Rezoning Transportation Analysis
Petition Number: Insert Zoning Petition #2021-060
General Location Identifier: 09509220

Revision Log:	Date	Description
	05-27-2021	First Review (WB)

Transportation Summary

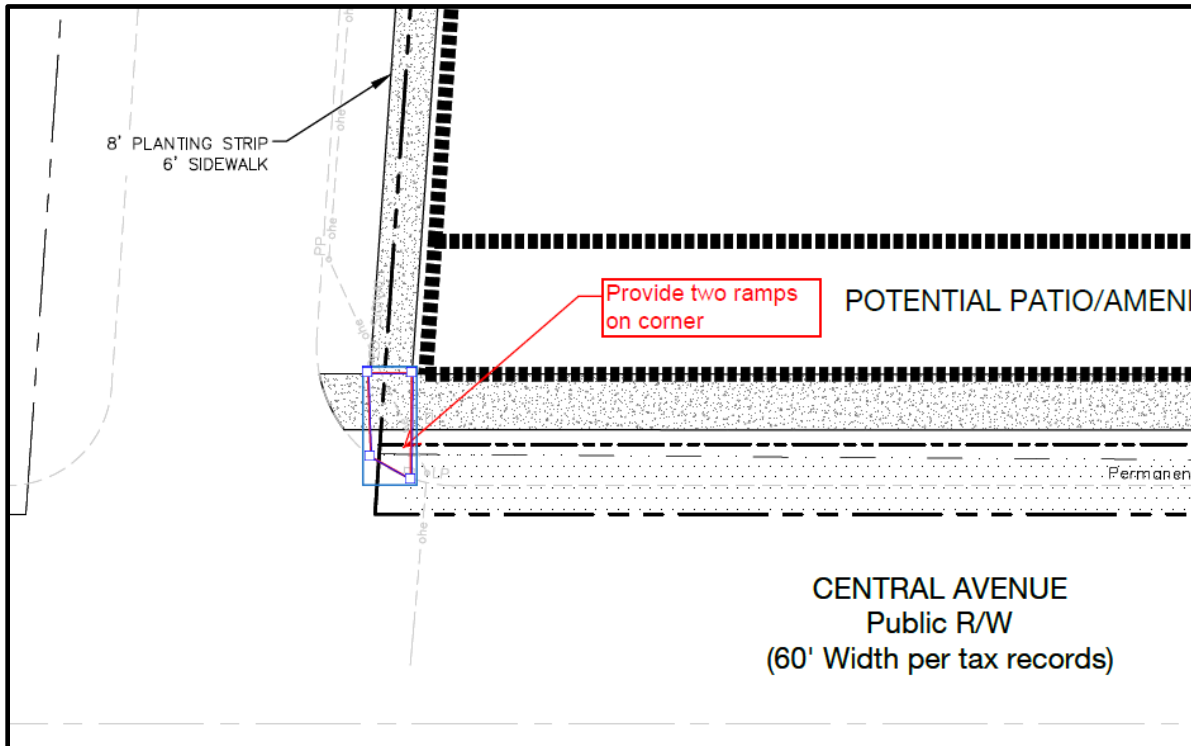
1. **Curbline:** The proposed zoning district has a setback measured from back of the existing or proposed future curbline.
 - a. **Central Avenue:** The future location of curb and gutter is in its existing location.
 - b. **Morningside Drive:** The future location of curb and gutter is in its existing location.

Label and dimension the curb and gutter from the centerline for each road on the site plan.
